**Main Drainage Channels for Fanling, Sheung Shui and Hinterland
EIA - Final Assessment Report**

EIA for Main Drainage Channels for Fanling, Sheung Shui & Hinterland
ACE-EIA Sub-committee

Ref : The letter from World Wide Funds for Nature Hong Kong (WWFHK) dated 31 October 1997

SK210

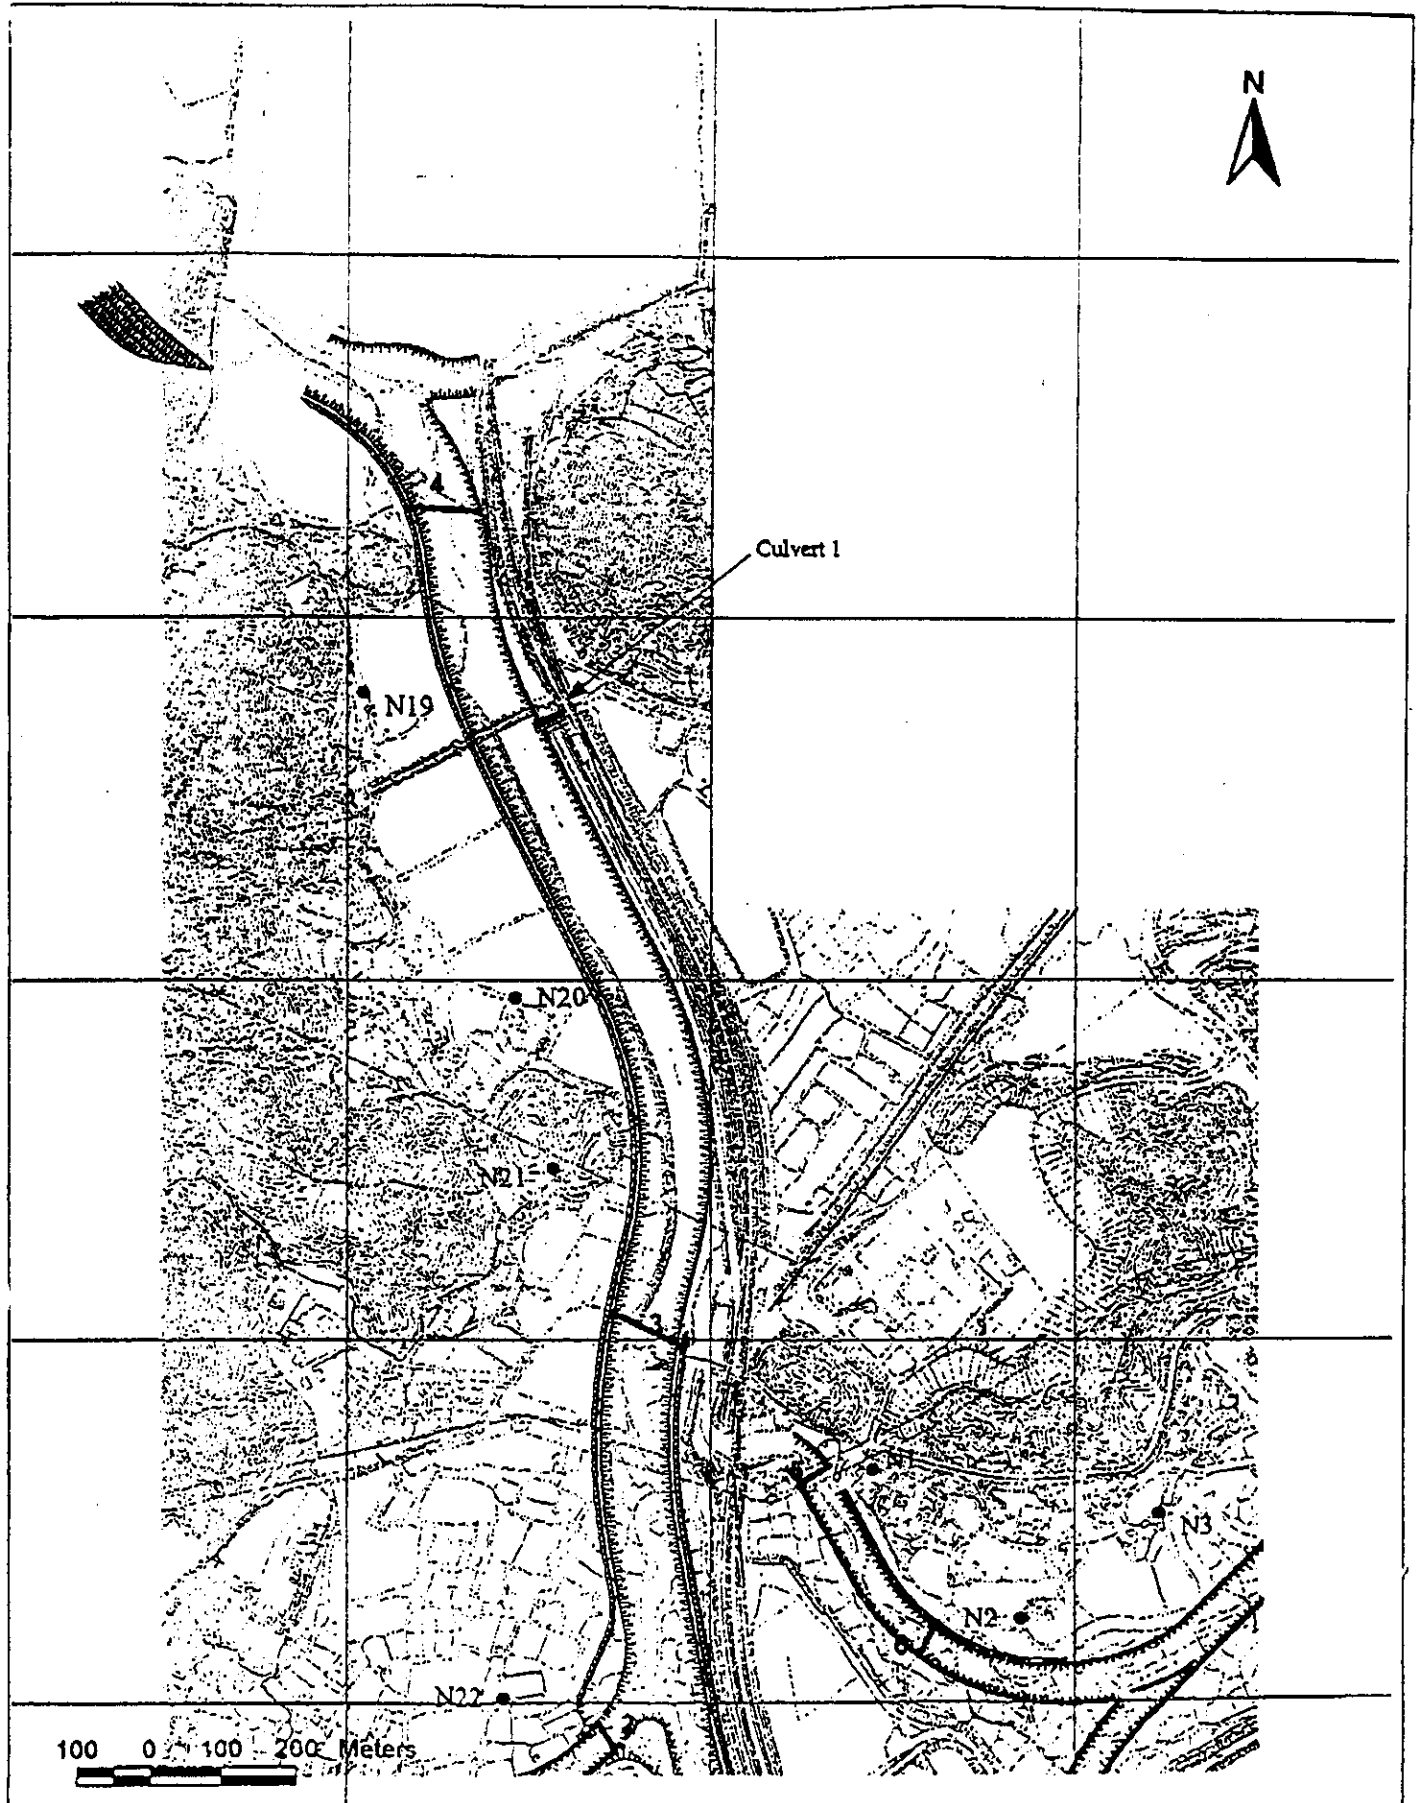
- iv. The Report stated that 'the marsh area [of Type 1 meander] can be connected to the river part of the meander so that water levels can be controlled to any level.' Please would the proponent explain how this could be achieved. How would the water levels of marsh areas in Types 2 and 3 meanders be controlled or managed? Please would the proponent also discuss subsequent management responsibilities for controlling the water levels.

Site specific designs will be made at the detailed design stage. What follows is a summary of the methods to achieve water level control. Figure No. SK 210 showing the schematic arrangements of the various meander types is attached for easy reference.

TYPE 1: This type of meander is relatively simple in that the meander channel will form part of the tributary. In all cases the meander channel is much larger than the tributary draining to it so that enlargement will not be required. In the Upper Indus, the meander channel base will be below the level of the water in the river due to the fabridam so that there will always be water in the meander channel and a through-flow. A flap valve is required at the outlet to prevent backflow from the river.

TYPE 2: There are three Type 2 meanders on the Upper Indus all of which have no significant tributaries. The levels of the existing channel in the meanders (varying from approximately 1.00mPD to 2.7mPD) will be below the level of the water in the main channel which will be controlled to a level of approximately 3.4mPD by the proposed weir. Given the sandy silty type of ground, the ground water level across the meander should stabilise at a level similar to that in the river.

Therefore, the base can be adjusted to form a pond (with excavation depending on depth required), raised to a level at slightly below 3.4mPD to form a permanent wet area or raised slightly higher so that the area is seasonally wet as the river level rises during the wet season.

Therefore, an outlet with flap valve will be required to drain the meander. When there is rain, the water level will rise so that it is always slightly above the level in the river. If the river continues to rise within the embankment above the level of the ground adjacent to the meander, flooding and spillage from the meander will occur. If the water in the main channel continues to rise, the flap valve on the outlet from the meander will close to prevent back-up through the outlet pipe.

TYPE 3: This type of meander will be filled with a depression or swale which will collect rainfall. The concept is a simple one in that the depression would be seasonally wet and during intense rainfall a shallow pond would form in the depression. A weir outlet would be provided with a level close to the surrounding ground level so that if the pond filled, the water could top over the weir and discharge to the river through a flap valve.

The above explains the principles by which the wetland concept will be achieved. In terms of the water level controls, these would include standard items such as fixed weirs, flap valves etc which would be part of the normal drainage system and would be maintained by DSD. DSD have indicated that they would be responsible for maintaining the inflatable weirs on the Upper Indus.

TITLE
Locations of Noise Sensitive Receivers
and Bridges to be Reprovisioned (7 - 9)

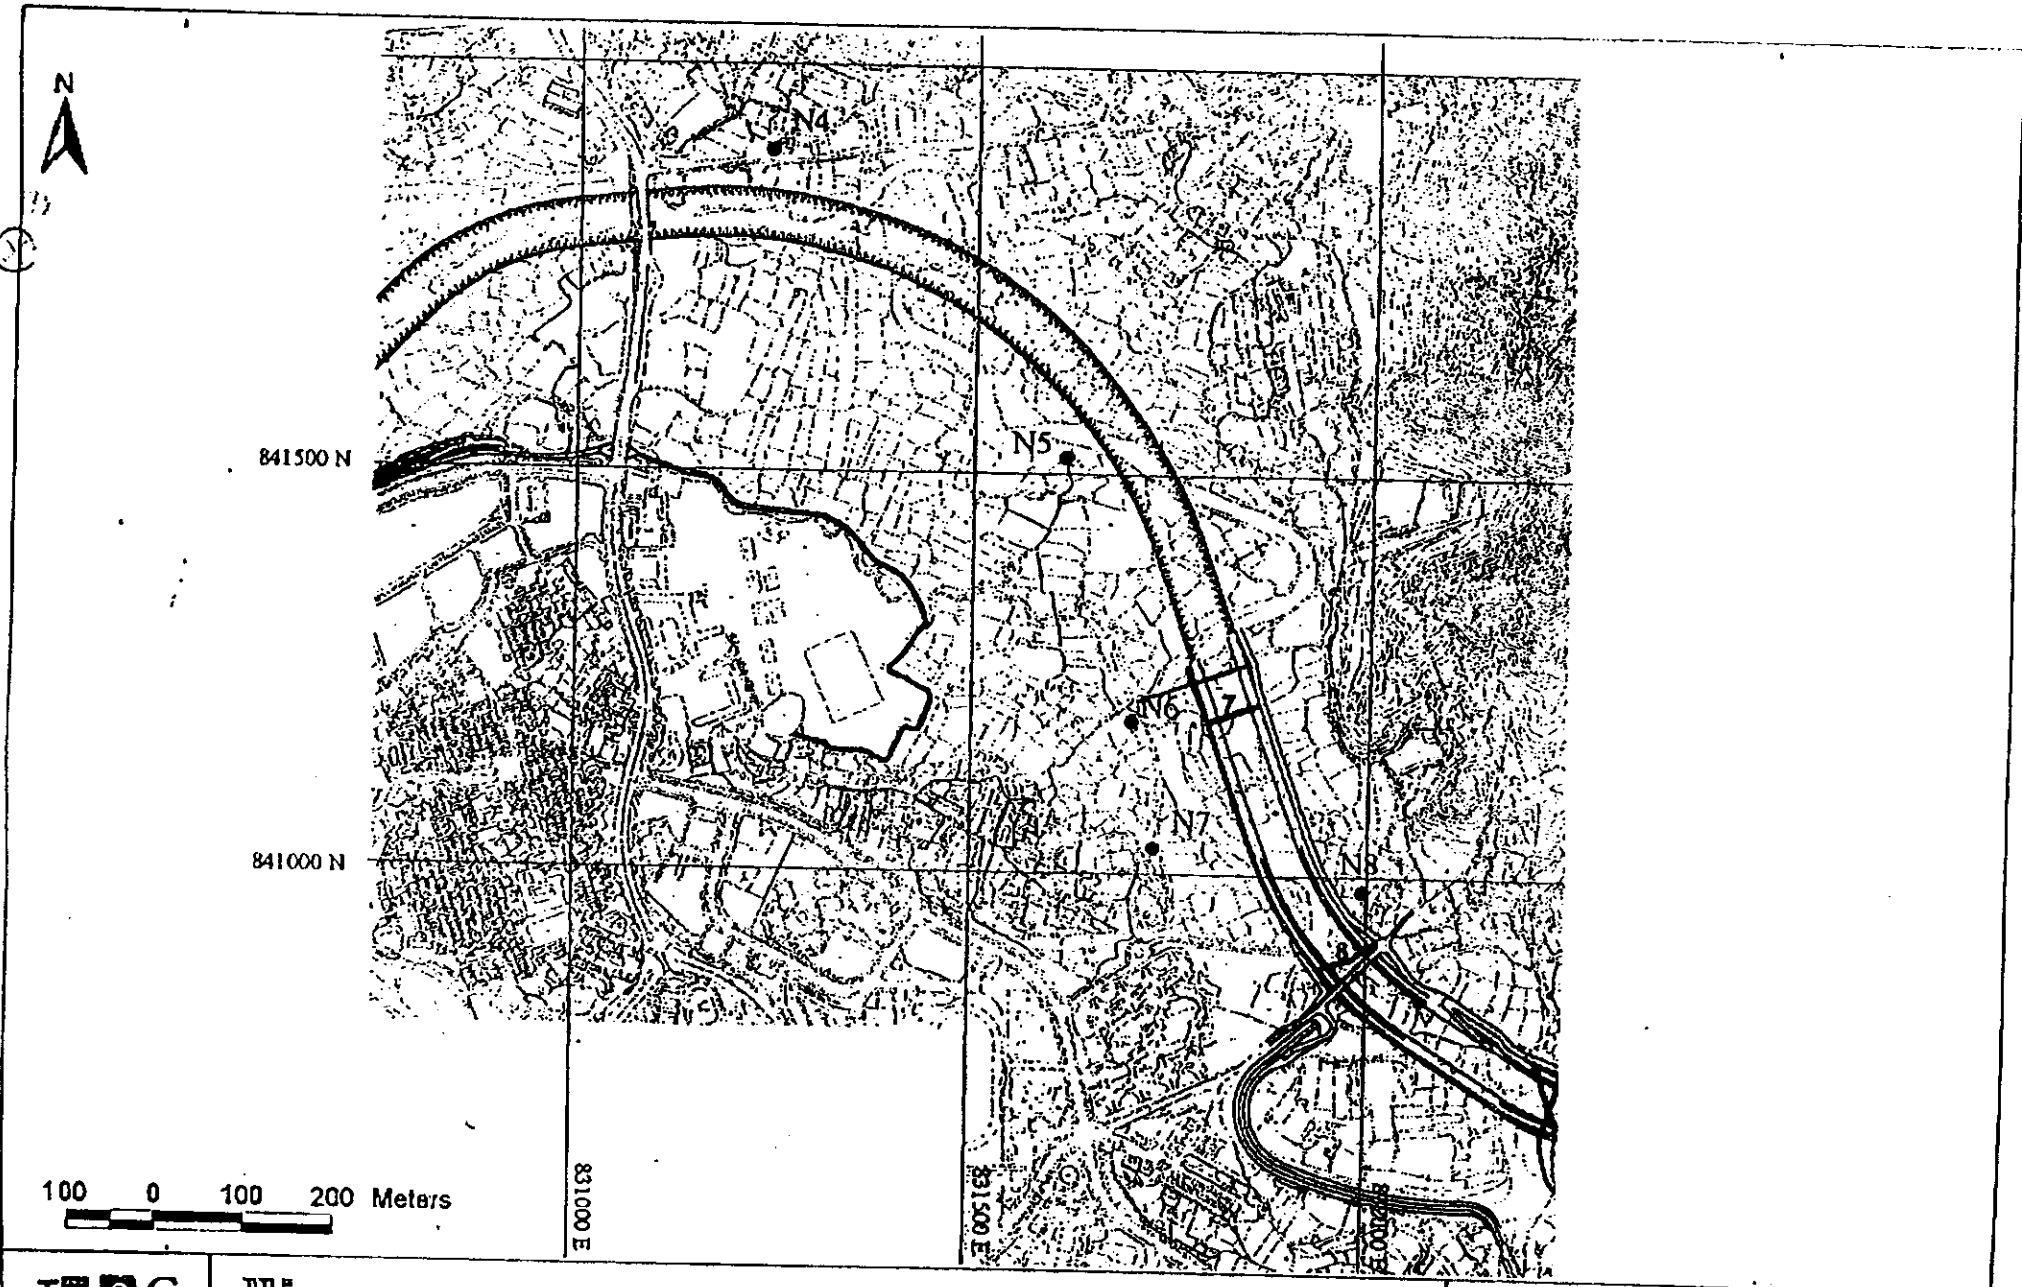
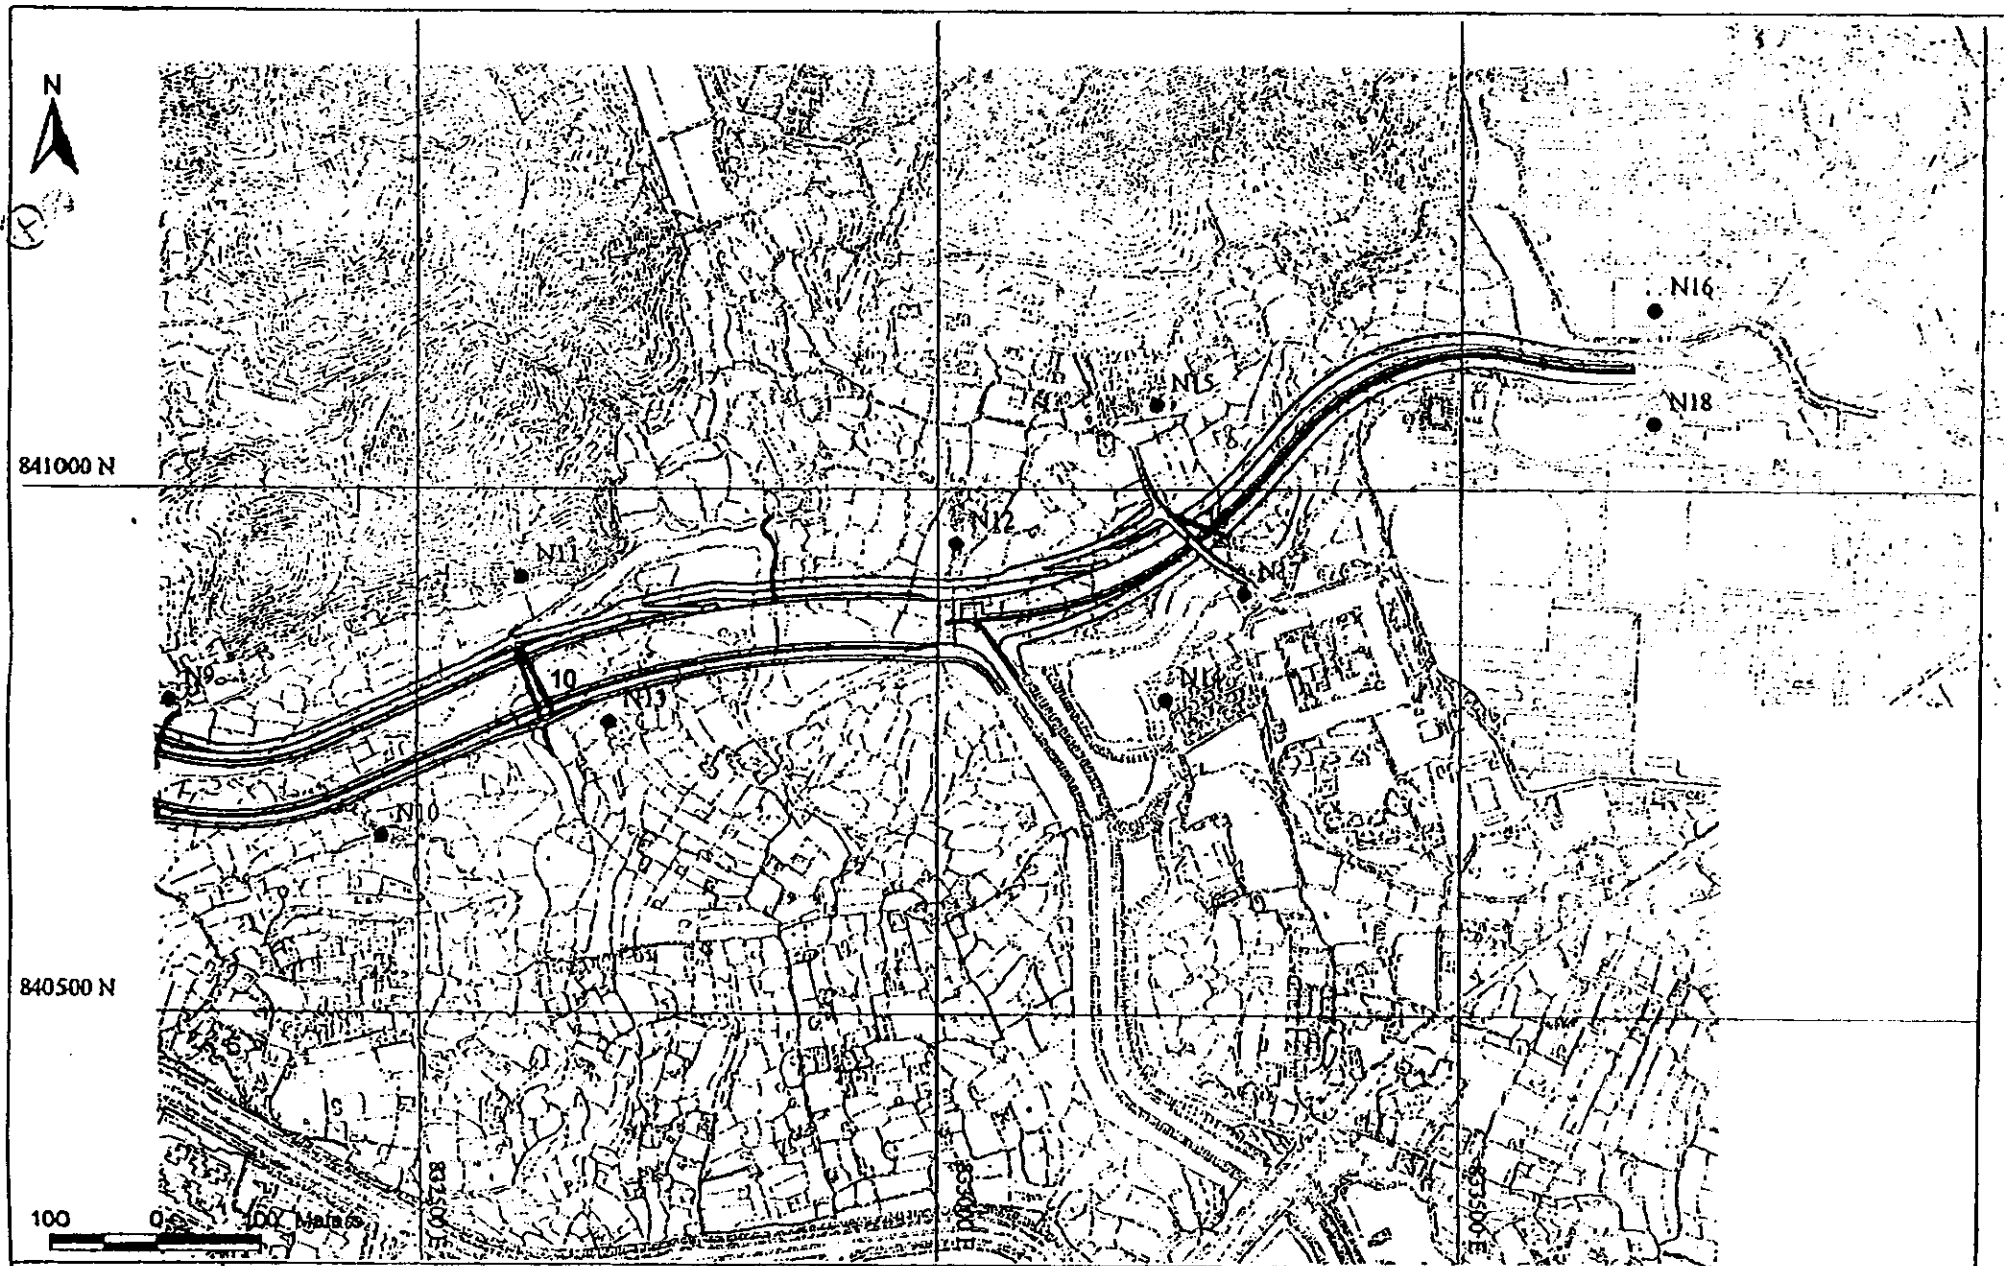
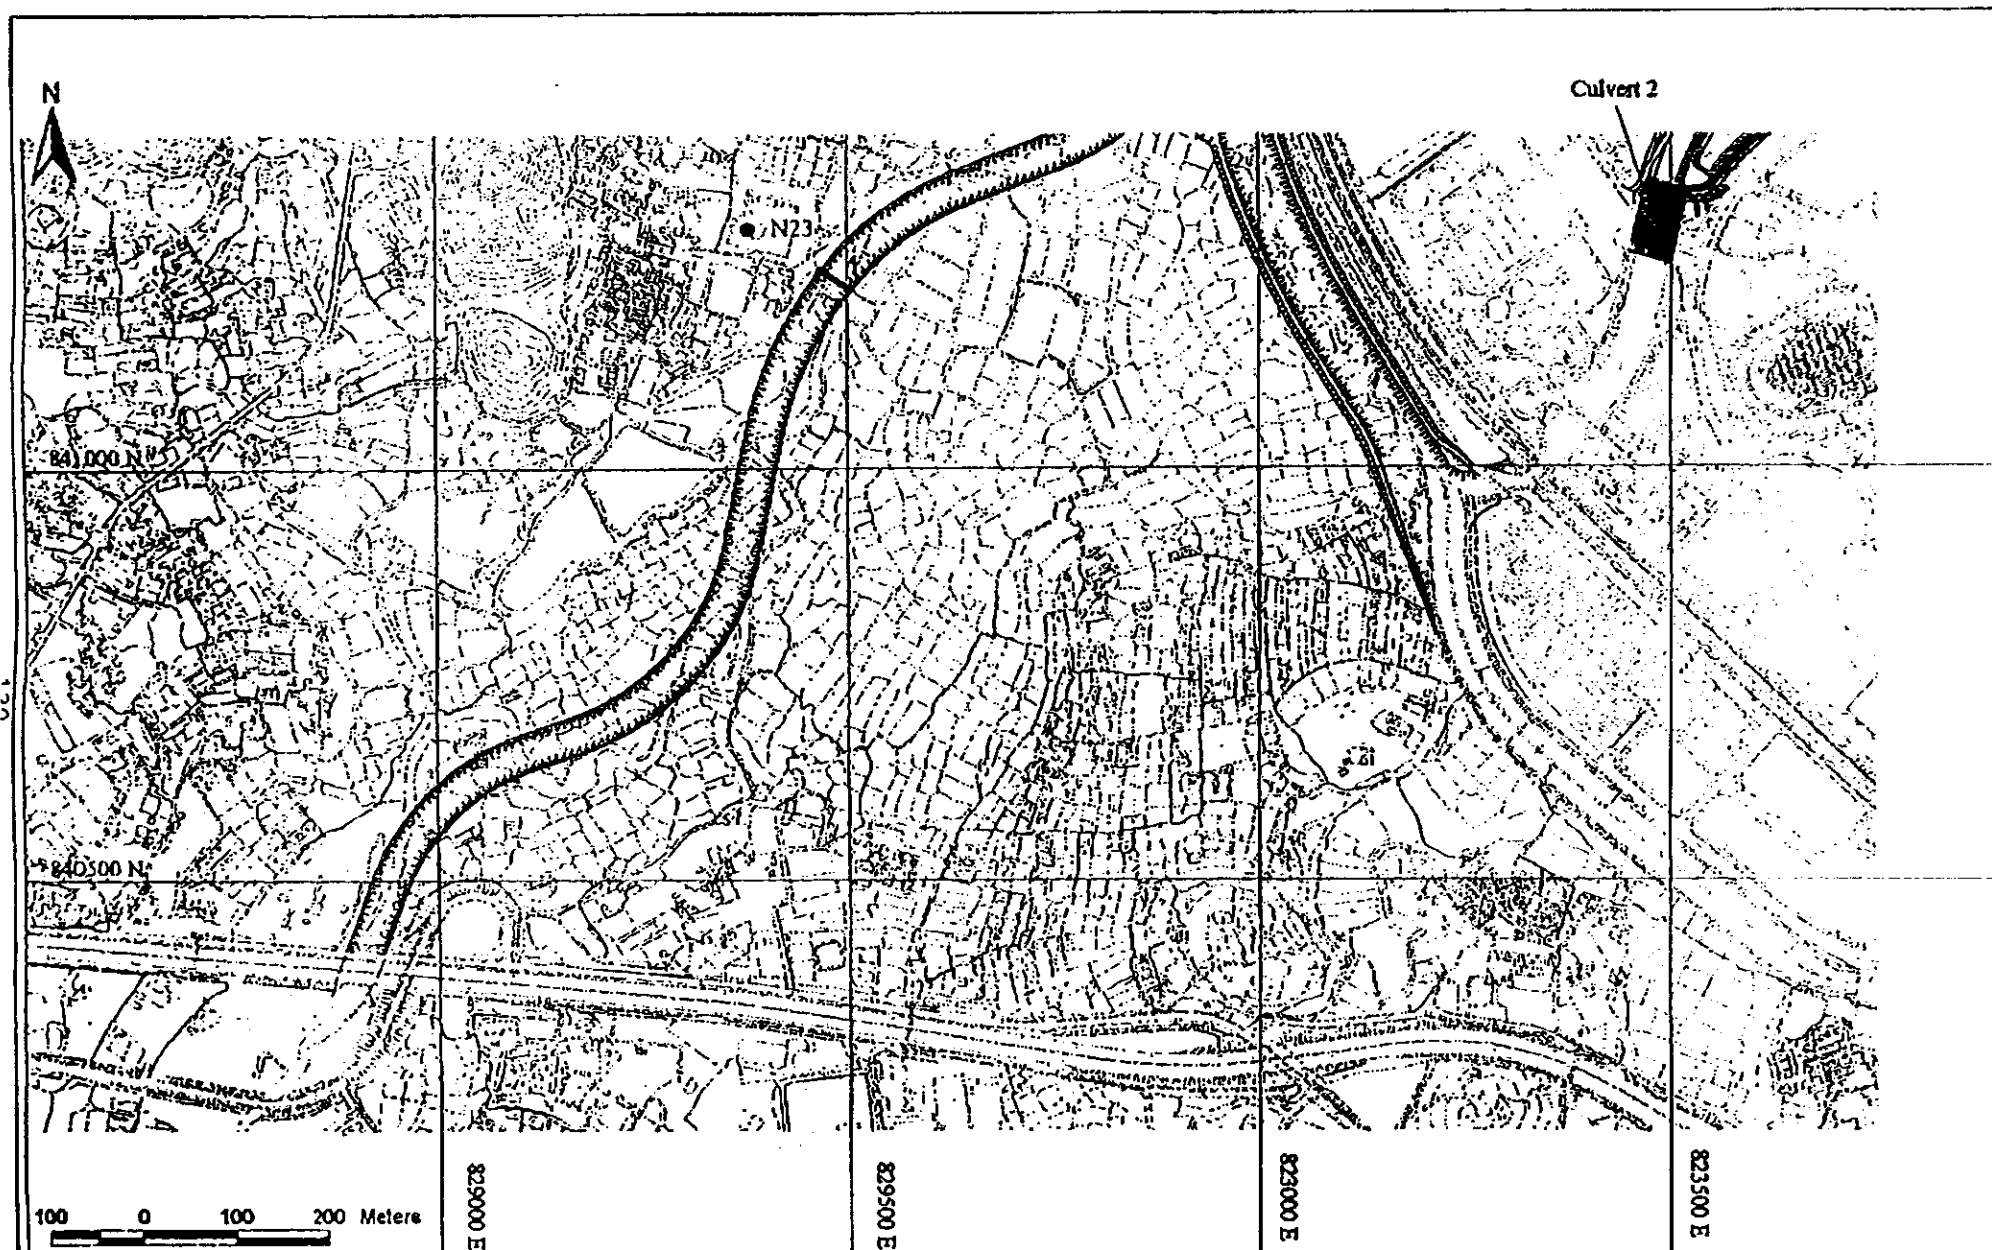
7.2 Figures 4.1 to 4.4 (showing the location of all selected representative noise receivers) are missing from the copy of the report I received. I should appreciate it if these would be provided to me at the earliest convenience.
